City of Santa Fe

REGULAR MEETING OF THE PLANNING COMMISSION OCTOBER 21, 2021 AT 6:00 PM MEETING VIRTUALLY

1. **Case #2021-4219. Monte Sereno Master Plan Amendment.** Al Lilly, Agent, for 21 Club Holdings LLC, Owner, requests Master Plan Amendment to include infrastructure and design elements for the Hotel Use. The Property is approximately 34.96 acres and zoned PRRC (Planned Residential Resort Community), located West of Highway 285, North of Tano Road at 4000 Monte Sereno Drive, and is within the Monte Sereno Development. (Dan Esquibel, Case Manager, daesquibel@santafenm.gov,505-955-6587)

2. **Case #2021-3800. Monte Sereno Development Plan.** Al Lilly, Agent, for 21 Club Holdings LLC, Owner, requests development plan approval to construct 170,000 square feet of new construction for hotel use. The Property is approximately 34.96 acres and zoned PRRC, located West of Highway 285, North of Tano Road at 4000 Monte Sereno Drive, and is within the Monte Sereno Development. (Dan Esquibel, Case Manager, daesquibel@santafenm.gov,505-955-6587)

SCALE	DWG NO.	DATE
1"=60'		06.21.2021
P&DR CASE #		SHEET NO. L-100

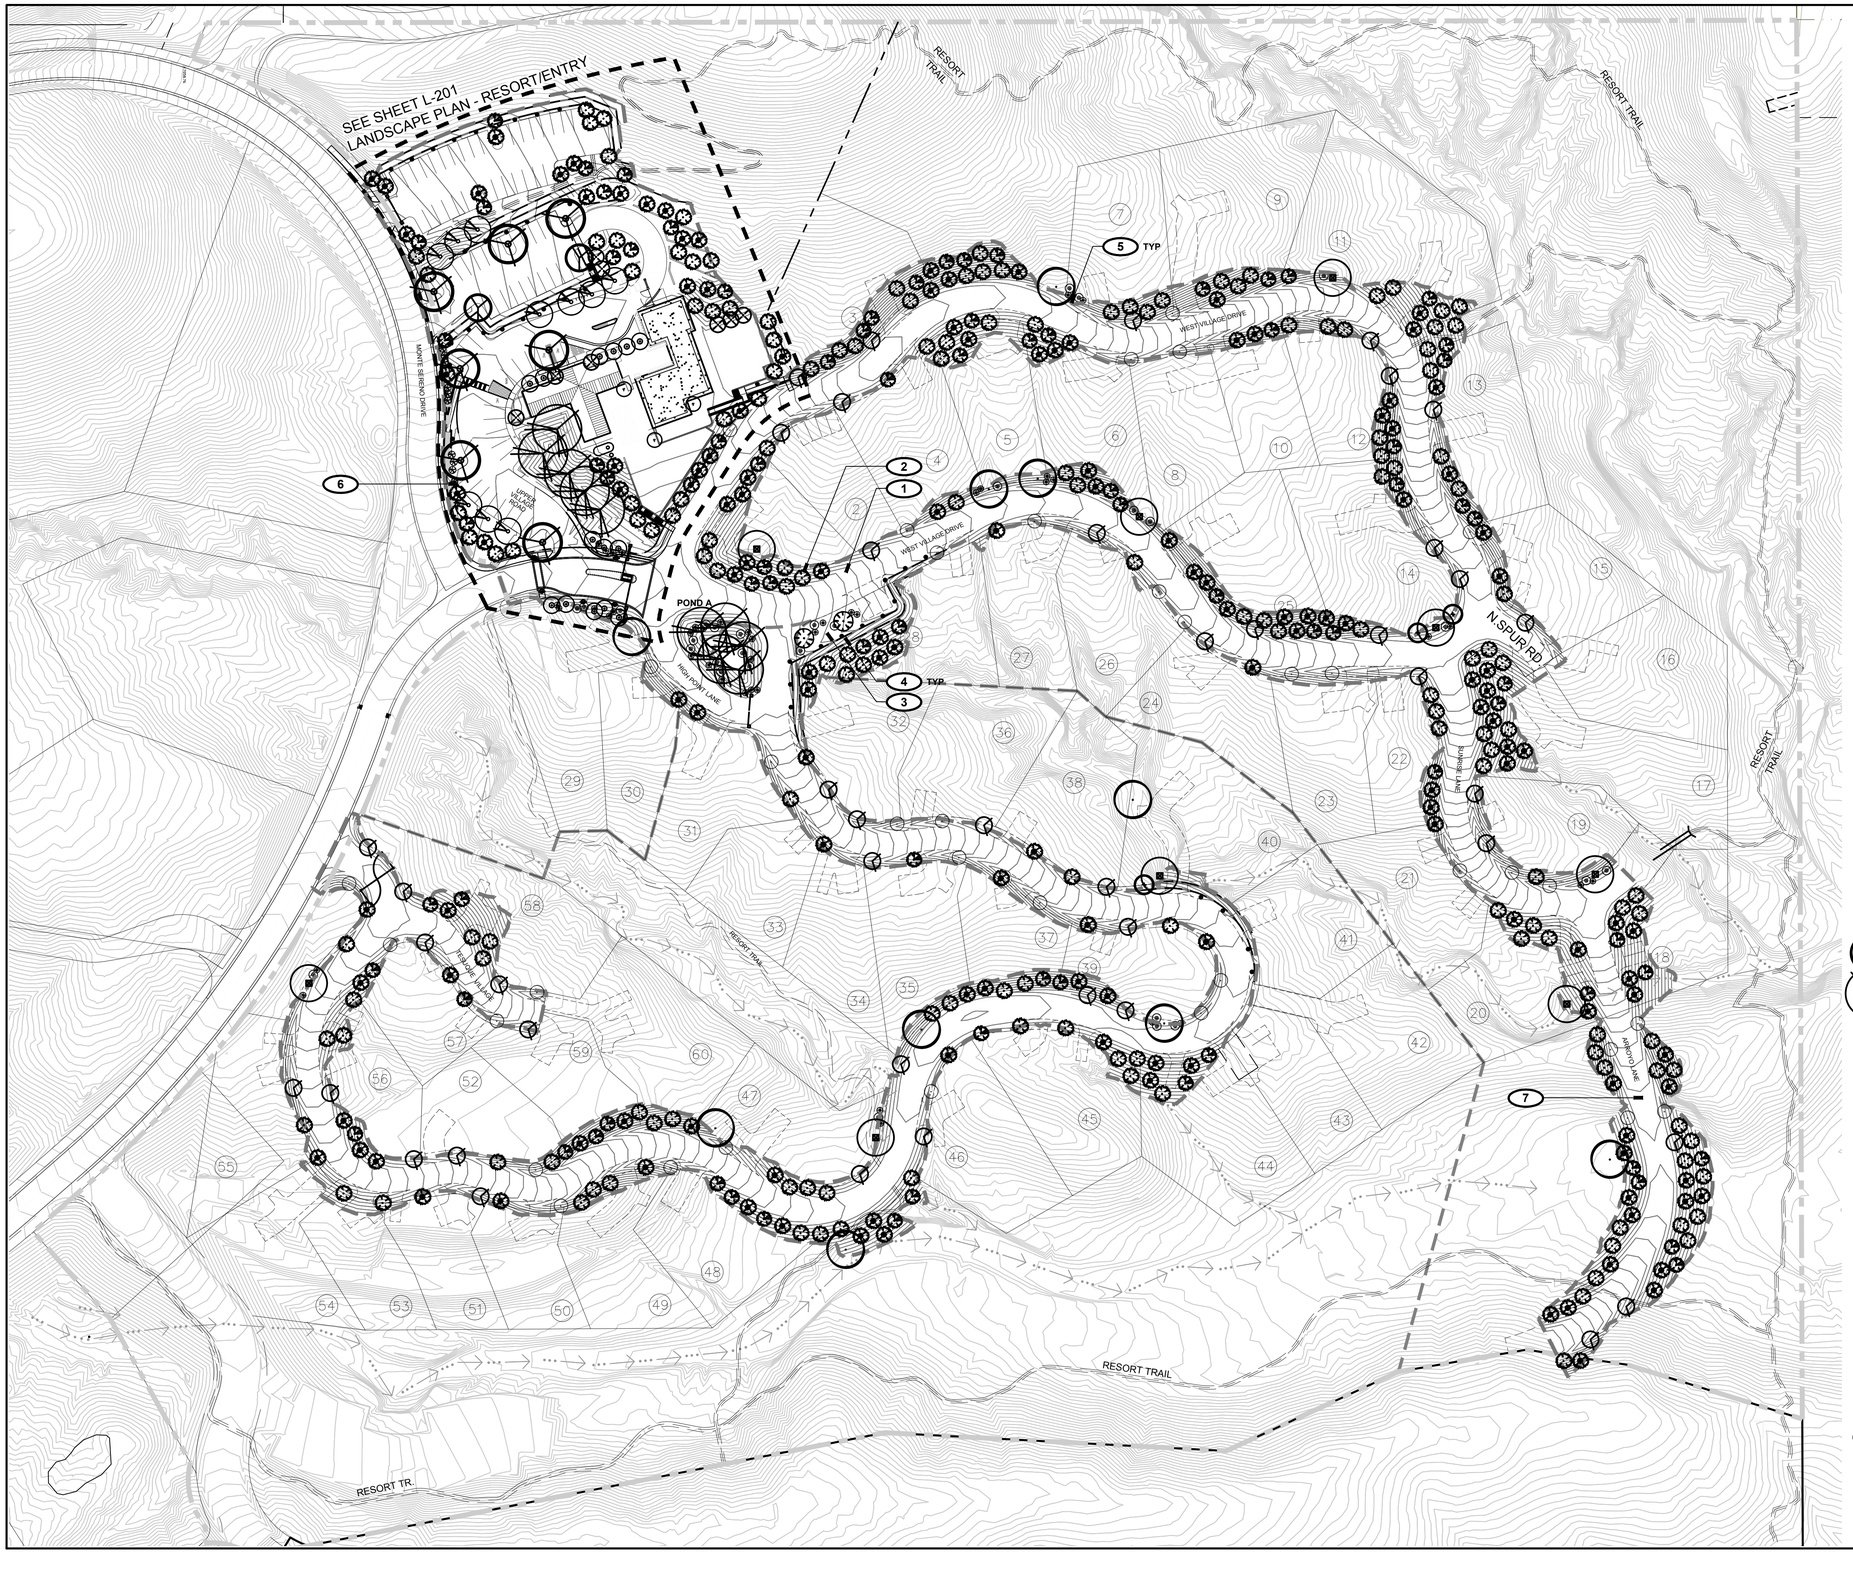
2. Sheet L-100. Delineate limits of existing fill located on the site. Provide explanation of the status or the intent of this fill. How many trees were removed in the filled area?

DATE:	SCALE:	SHEET:
JUNE 2021	N.T.S.	C-300

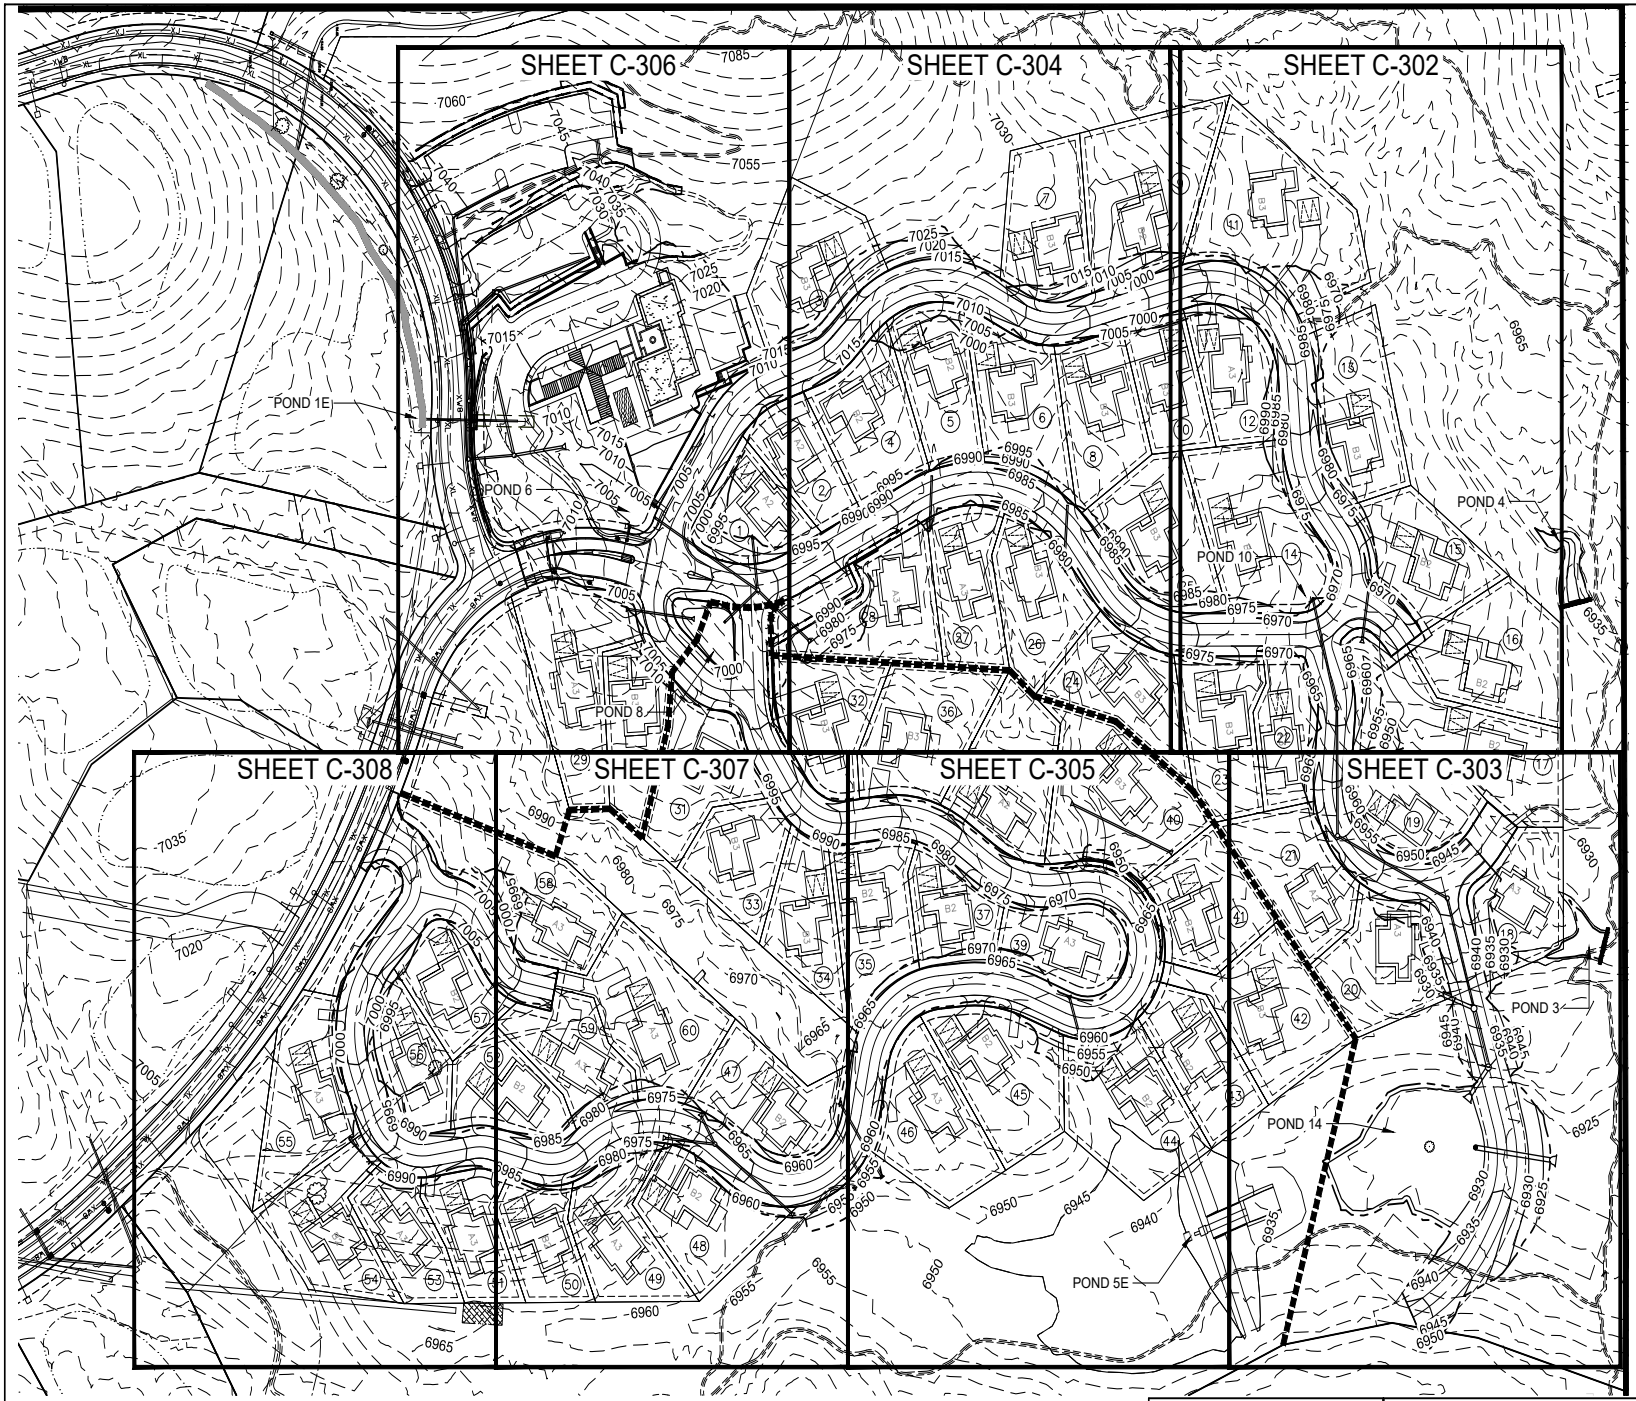
8. Sheet C-202. Same as item #7.
9. Sheet C-203. Same as item #7.
10. Sheet C-300. Provide explanation of the status or the intent of the existing fill. Does not appear to be considered in cuts and fills. Provide soils and drainage report.
